Location Address: 2351 THOMAS STREET, HOLLYWOOD, FL 33020
Lot(s): 10 W 7.75, 11,12 Block(s): 37 Subdivision: HOLLYWOOD PARK
Folio Number(s): 5142 09 05 6120

TO THE CITY OF HOLLYWOOD
DEVELOPMENT SERVICES - PLANNING DIVISION
TECHNICAL ADVISORY COMMITTEE REPORT – RESPONSE LETTER
COMMENTS AND **ANSWERS IN RED**

SUBJECT: Preliminary Site Plan and Design review for 18 Residential Units.

1 F SERIES MODEL #3306WHT-U, 8 DOORS & 4 PARCEL LOCKERS - PEDESTAL CLUSTER BOX UNIT (WHITE)
1/2" = 1'-0"

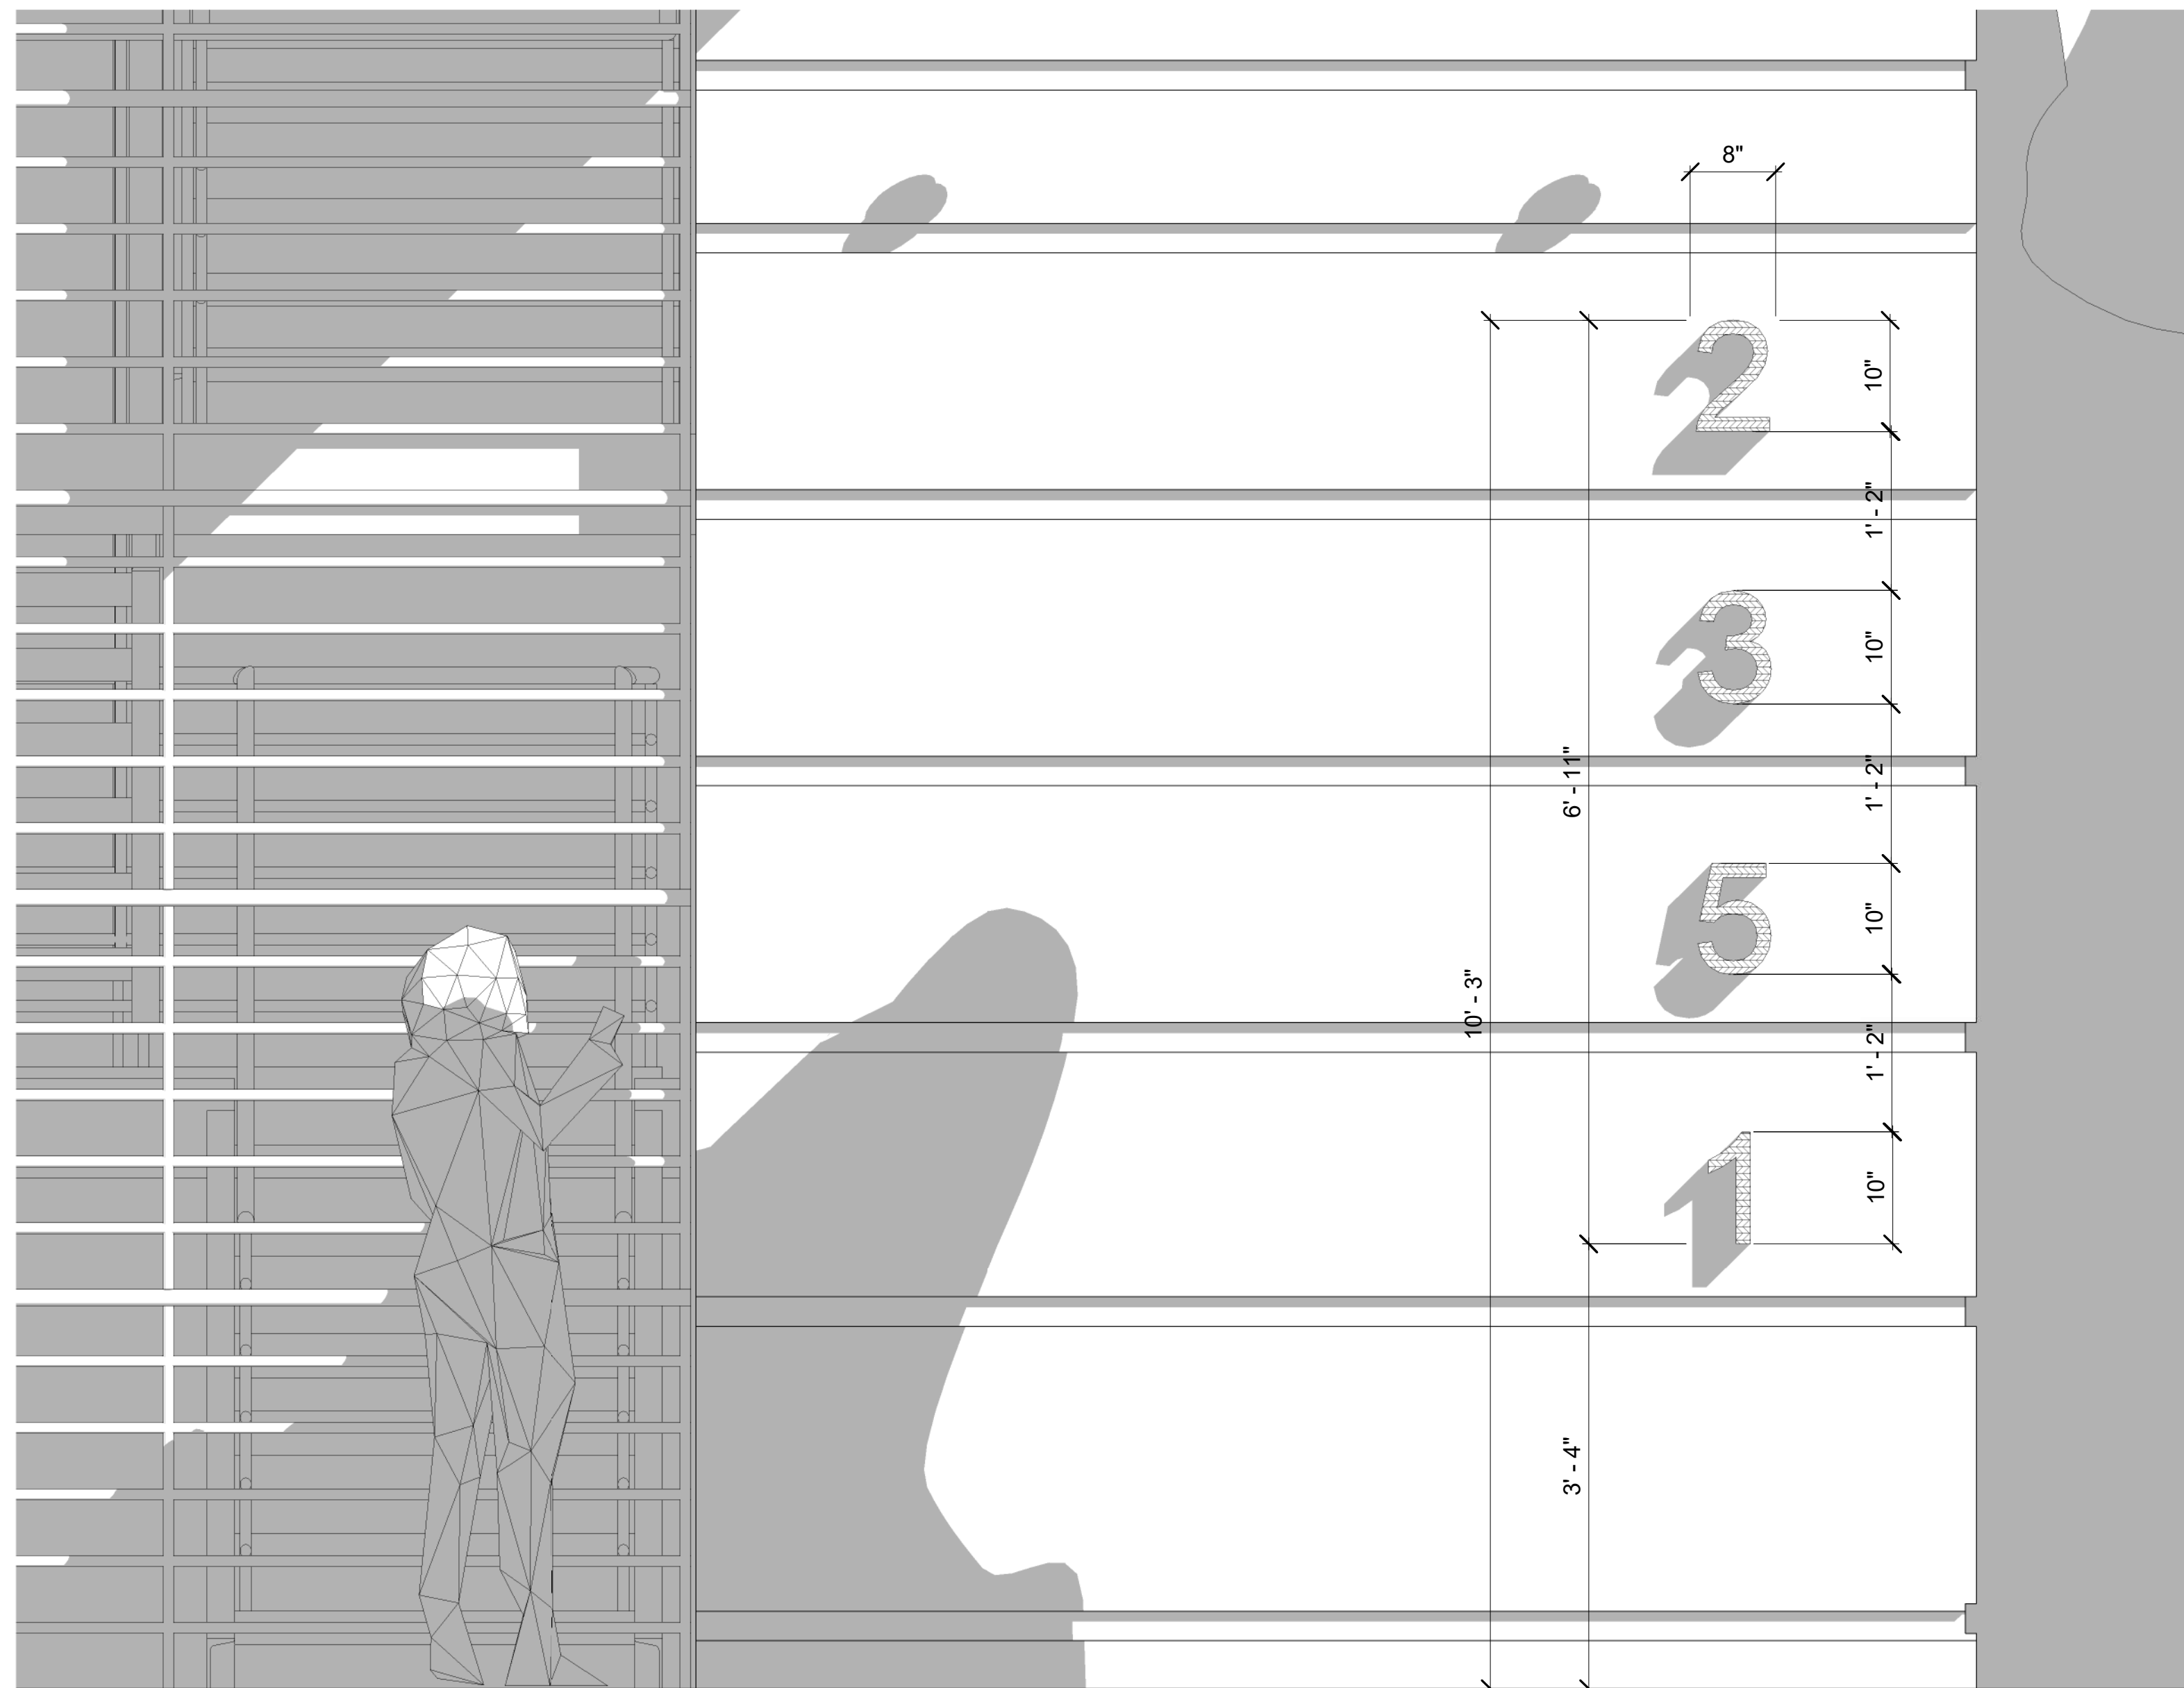
1. Identify location for mail delivery. **R. MAIL DELIVERY LOCATION INDICATED ON SHEET A1.0 AND FURTHER DETAILS AT SHEET A1.4 – CLUSTER BOX UNIT DETAILS.**

2ND FLOOR PLAN

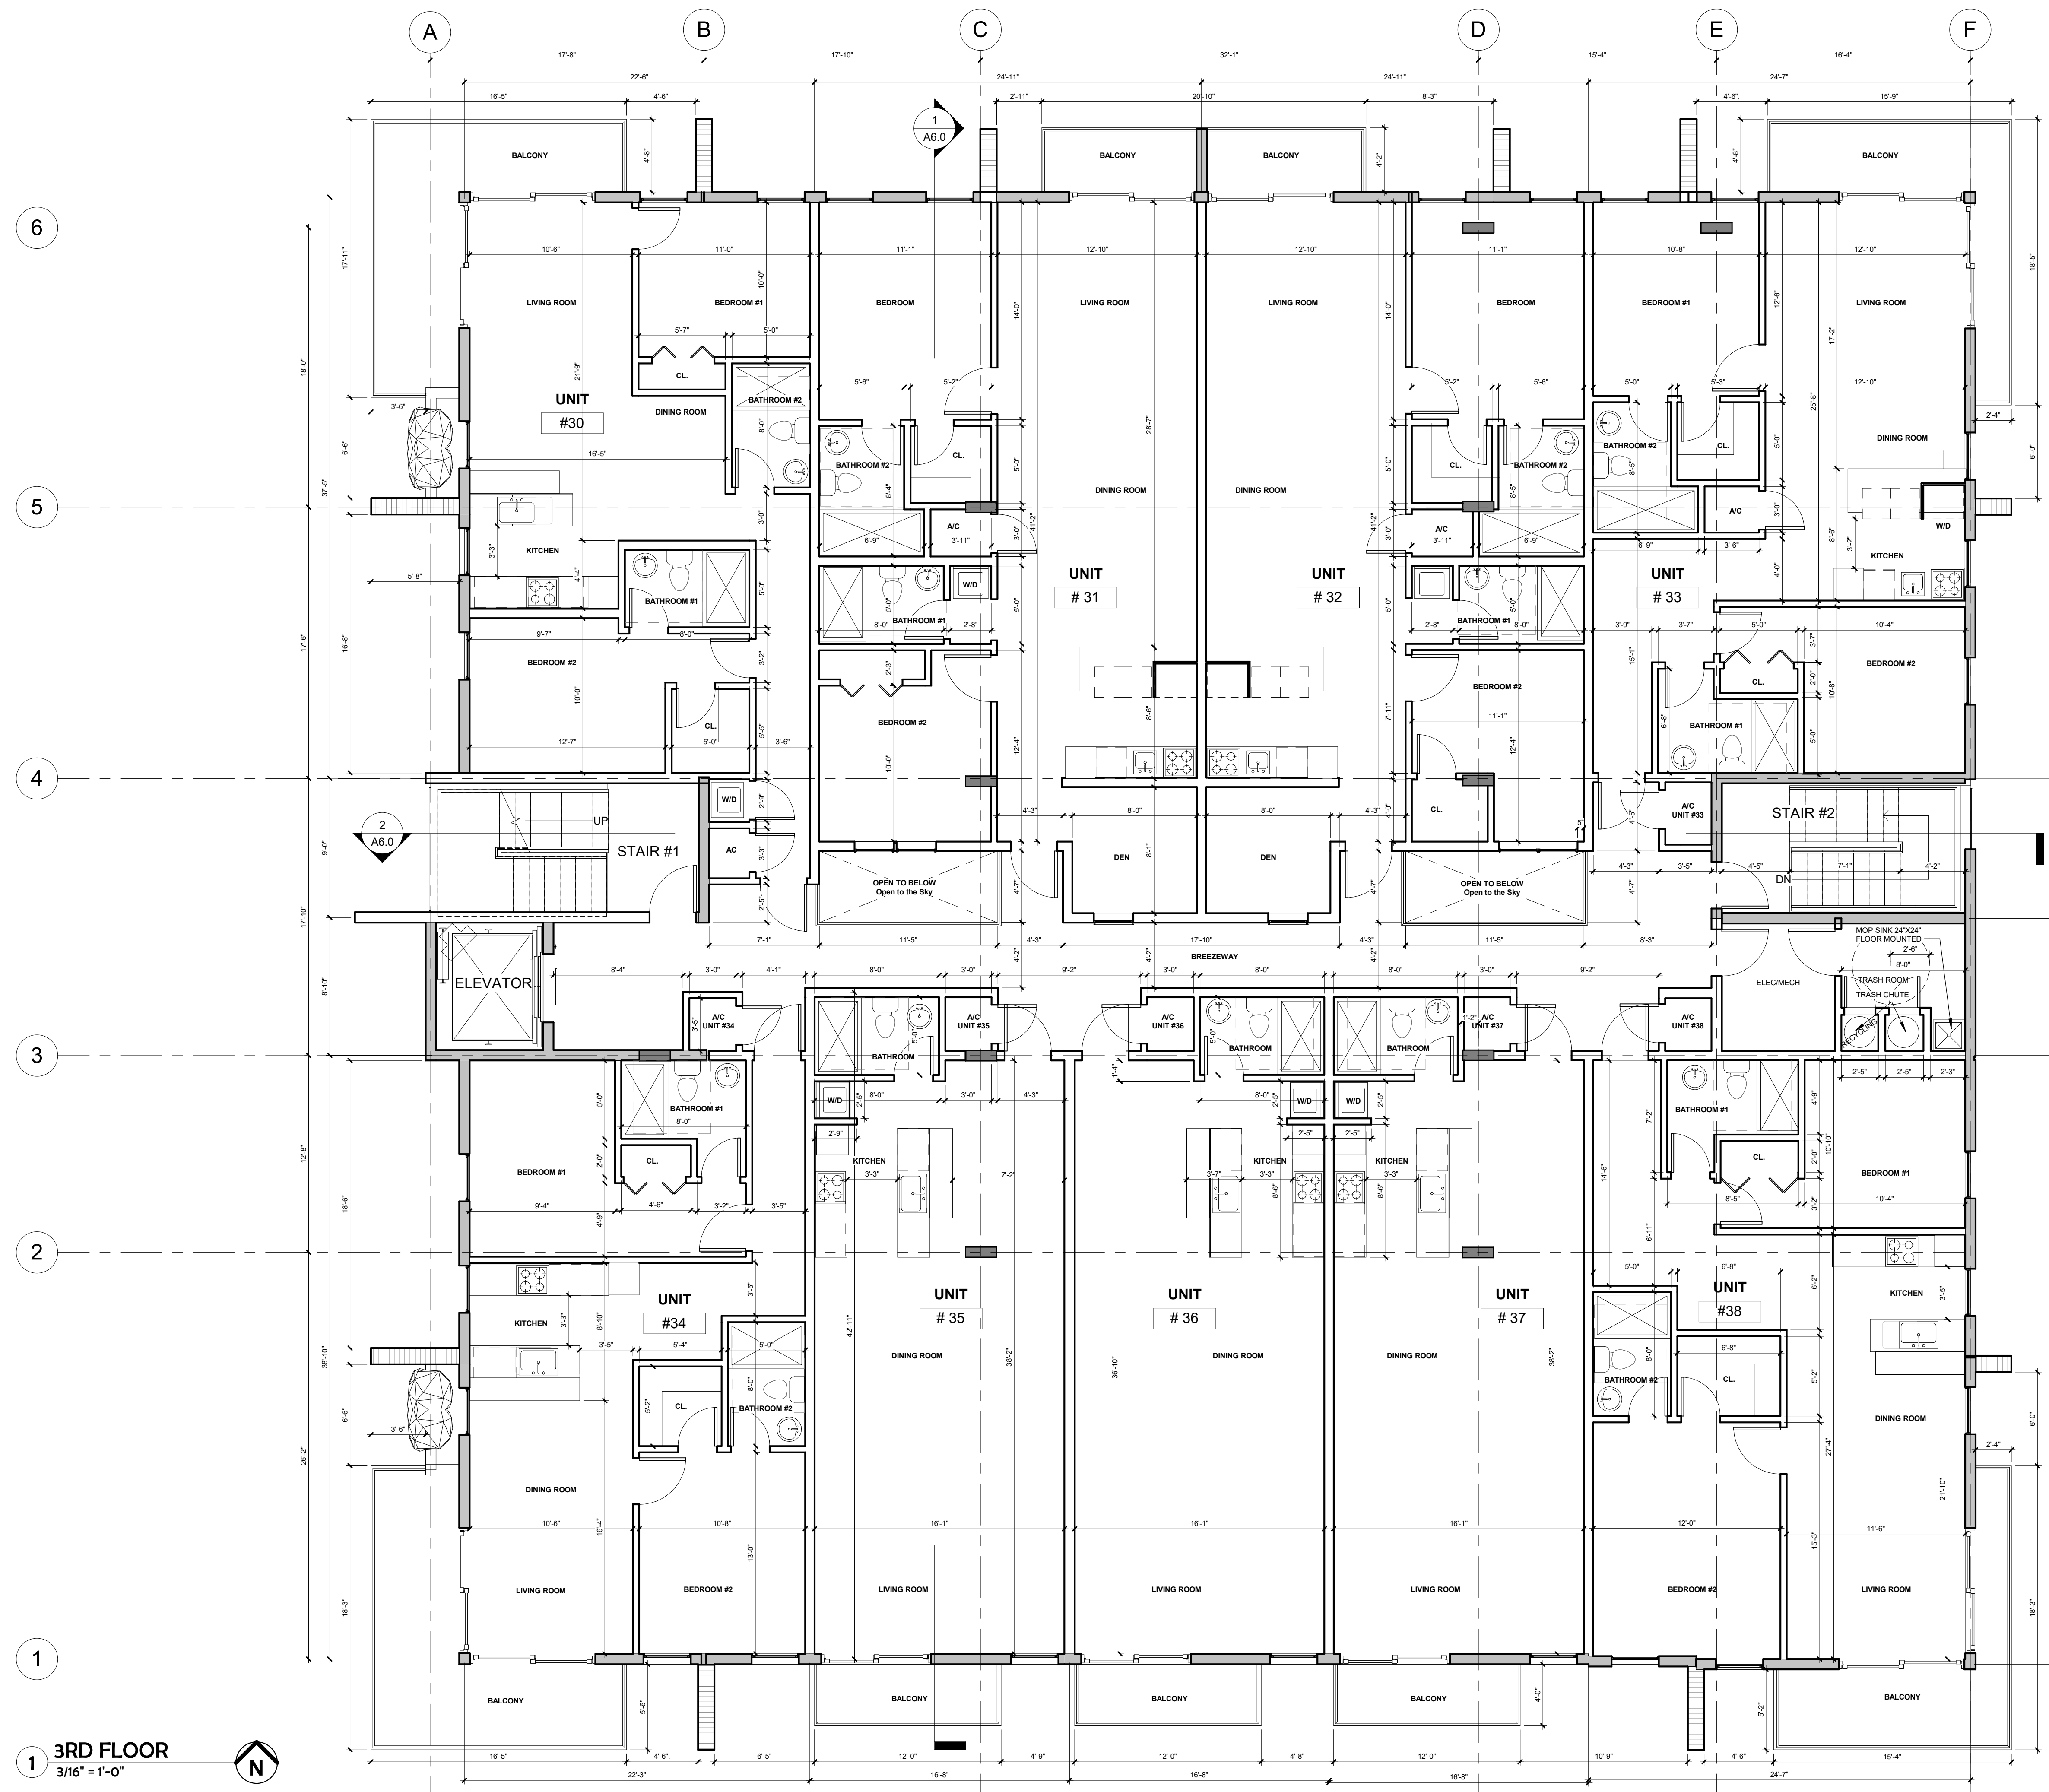
- i. Show dimension of egress only curb cut. **R. DIMENSION OF EGRESS SHOWN AT SHEET A1.0 – SITE PLAN.**
 - j. On Sheet A2.2, it appears the upper left unit is not accounted for. Continue unit count for accuracy. **R. UPPER LEFT UNIT IS ACCOUNTED NOW AS UNIT #30 ON SHEET A2.2.**

C1

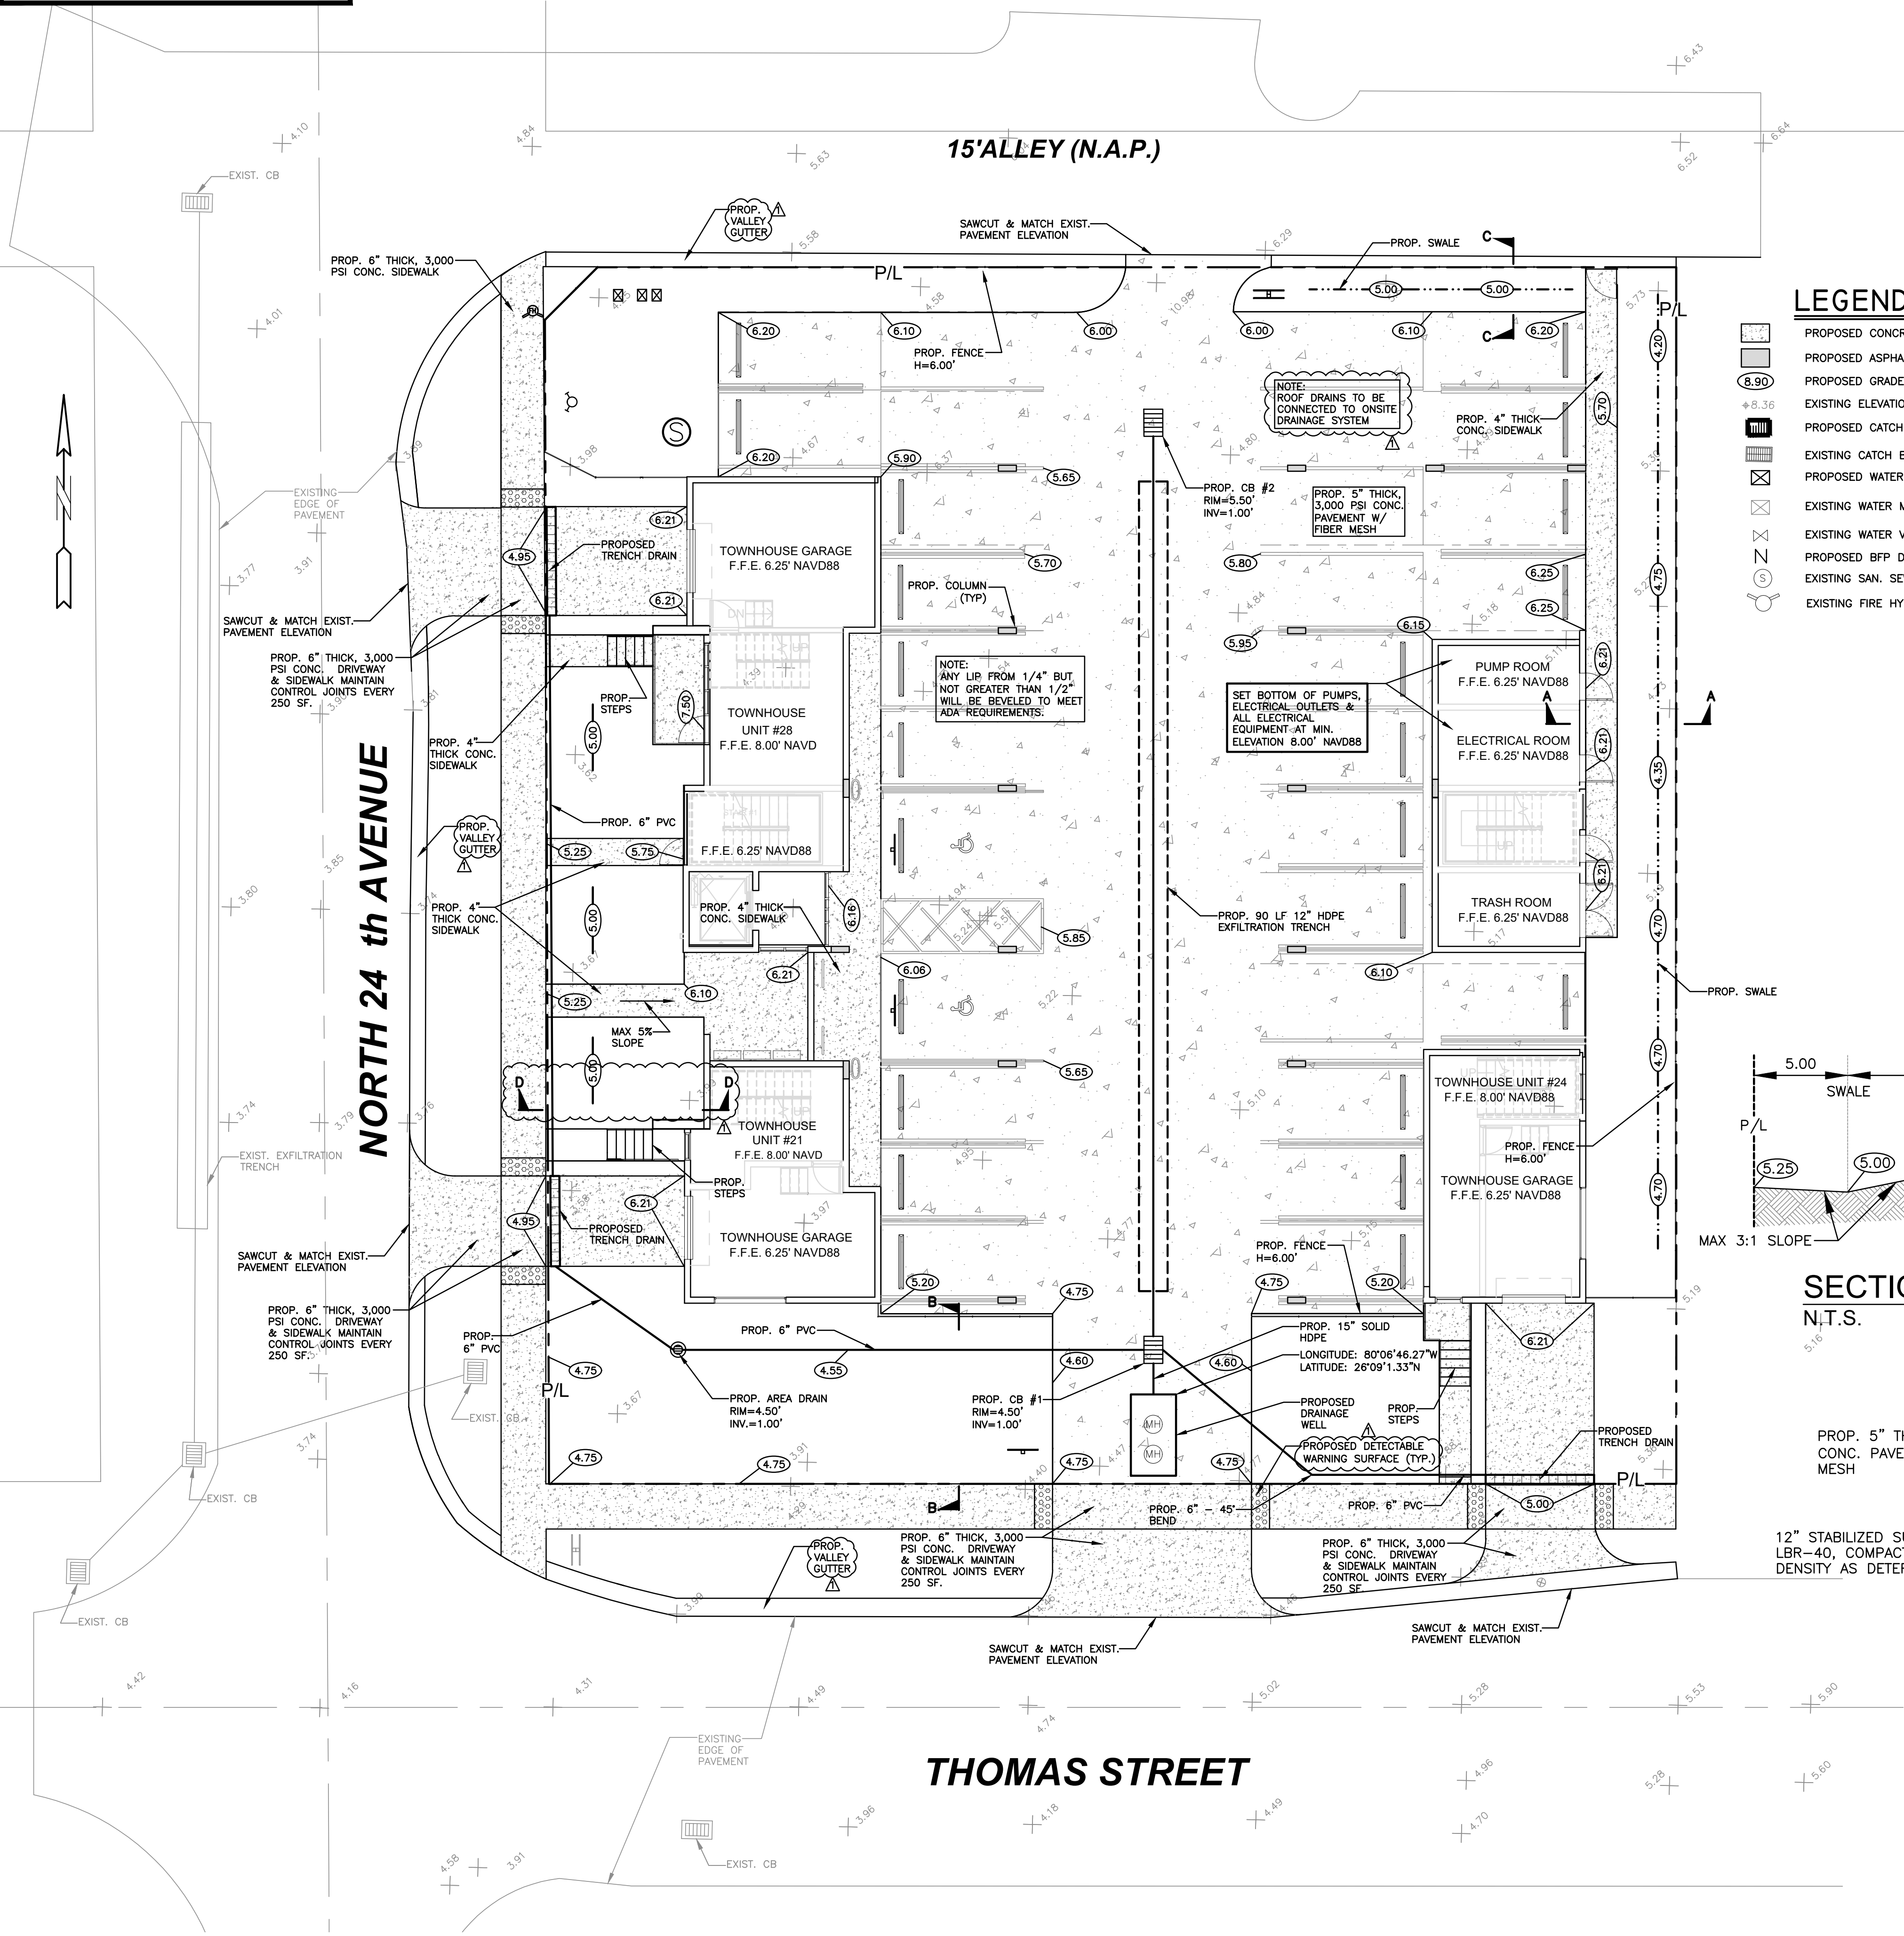
32. Civil sheet C-1 shows a driveway that does not align with the apron being proposed. Driveways and aprons must be the same width for the first 5 feet setback from the front property line before widening. Please correct. **R. SEE REVISED CIVIL PLANS, SHEET C-1.**
